Ahsan Knitting Ltd.

04th October 2022

Ahsan Knitting Building (G+5)

Observations

Geotechnical certificate

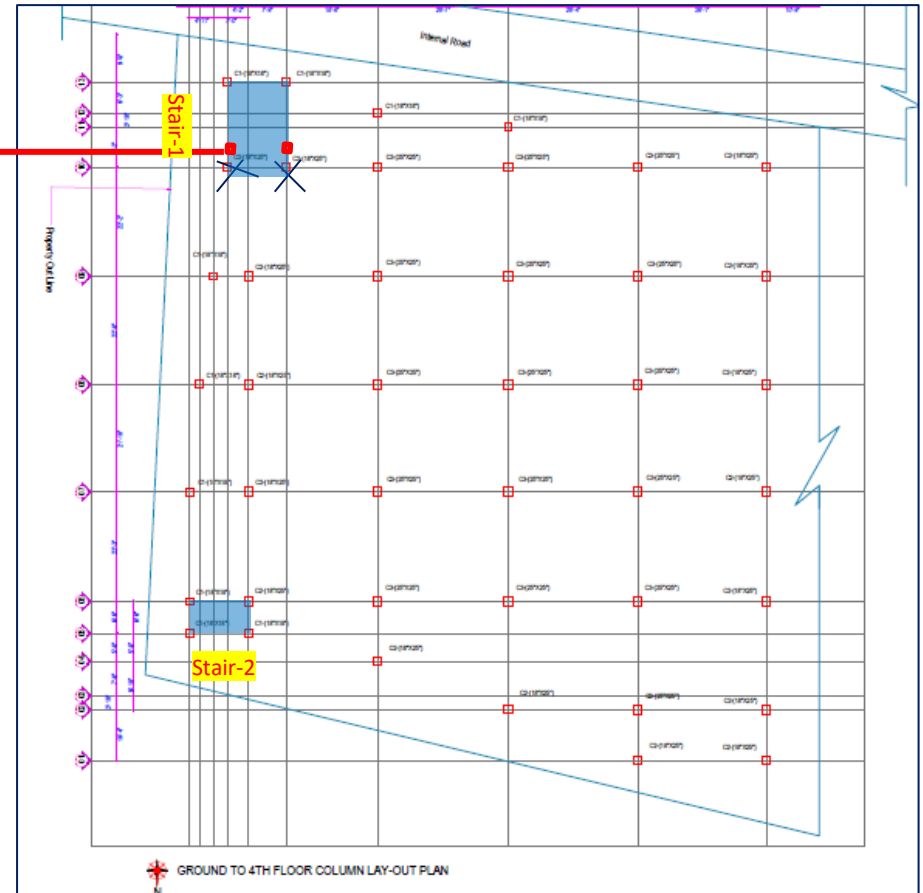
Incomplete geotechnical investigation report was found for the six storied factory building. Only a geotechnical certificate was available on site which shows allowable bearing capacity 4.5 ksf without having any bore log data. Thus, complete geotechnical investigation report for the building is required be prepared to confirm the foundation adequacy.

Column Layout

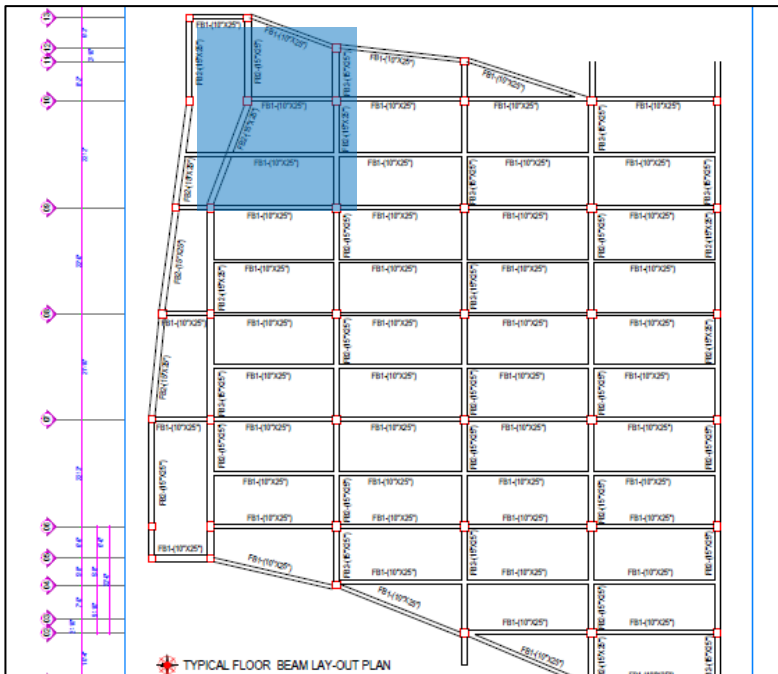
Column found offset from beam-column joint

Column and beam layout were not fully matched with drawings near stair-1. Mismatches are shown in the figure.

Stair column

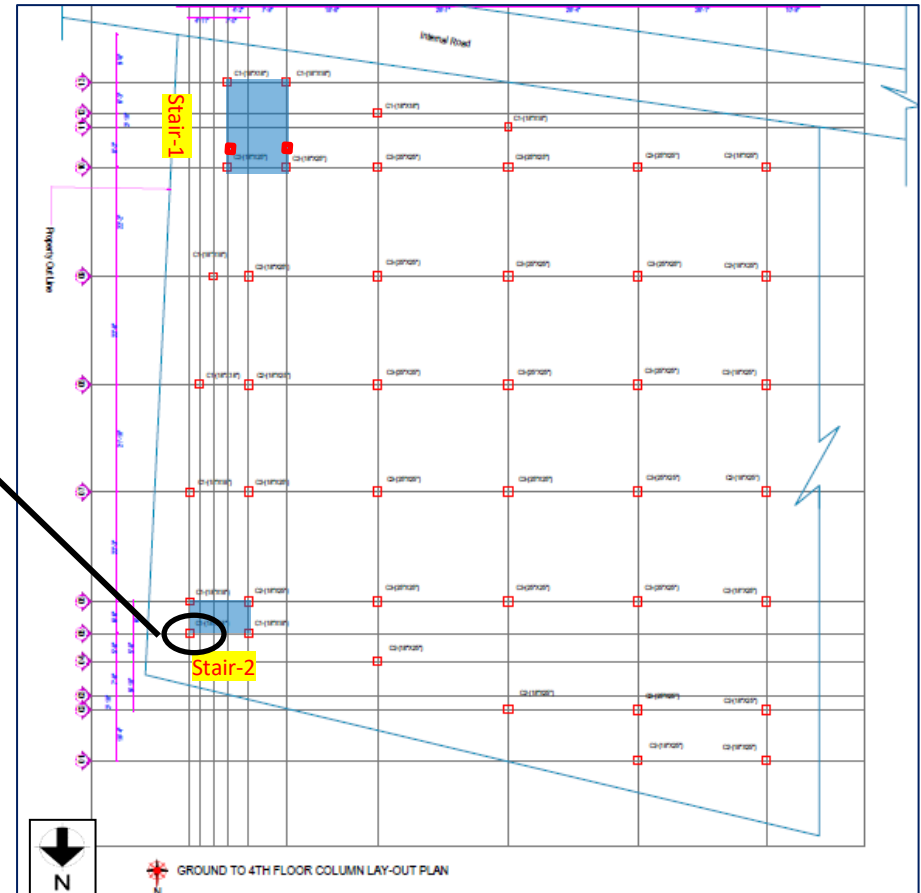
Size of corner column of stair-2 did match with column schedule. 15 X 10 inches were measured instead of 18 X 18 inches.

load plan with 3 kN/m² (63 psf) loading limit

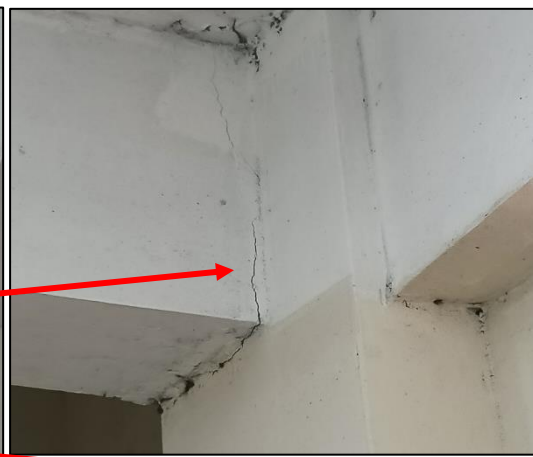
As per BNBC, the minimum floor live load for light storage is 6 kN/m² (125 psf). But, floor load plan for storage areas was found considering 3 kN/m². The building engineer is required to revise the live load plan as per BNBC requirement and prepare the design documents accordingly.

Crack found in Beam-Column Joint

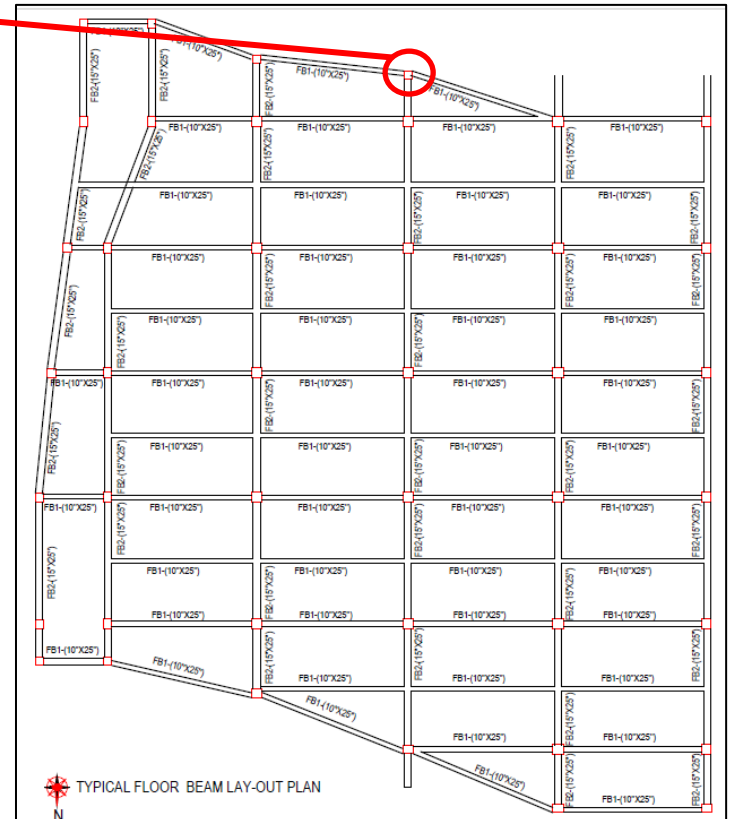
Crack found in beam-column joint (4th floor level) at south side of the building may caused due to poor workmanship. The factory engineer is required to investigate the causes of crack and repair with a suitable method.

Observation: Boiler & Generator Room

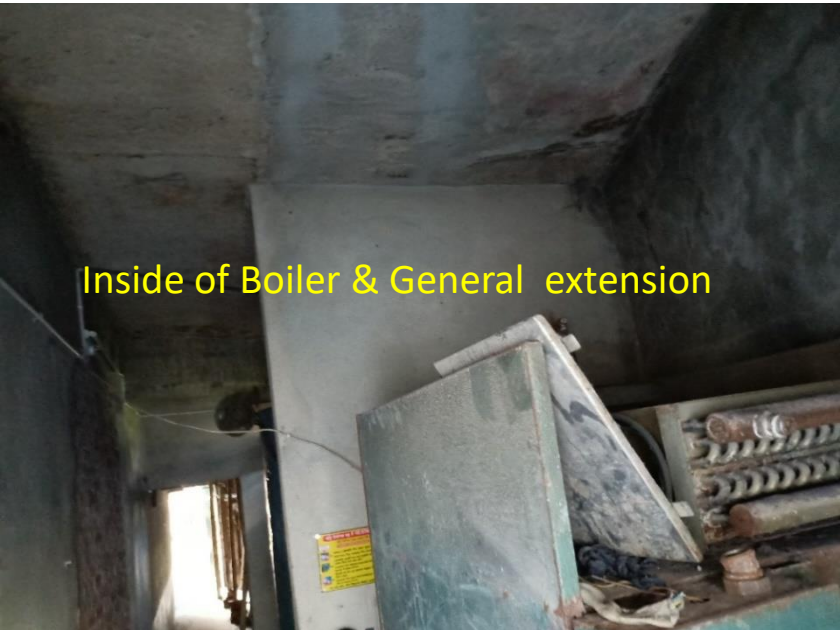
Undocumented single storied Boiler & Generator room was found at North side on ground floor level adjacent to the Ahsan Knitting Building. The roof of the boiler & generator room is supported by the cantilever portion of the Ahsan Knitting Building and boundary wall.

Building engineer is required to prepare as built drawings for the Boiler & Generator room and check the adequacy of the cantilever slab of Ahsan knitting building that supports the roof of the Boiler & Generator room.
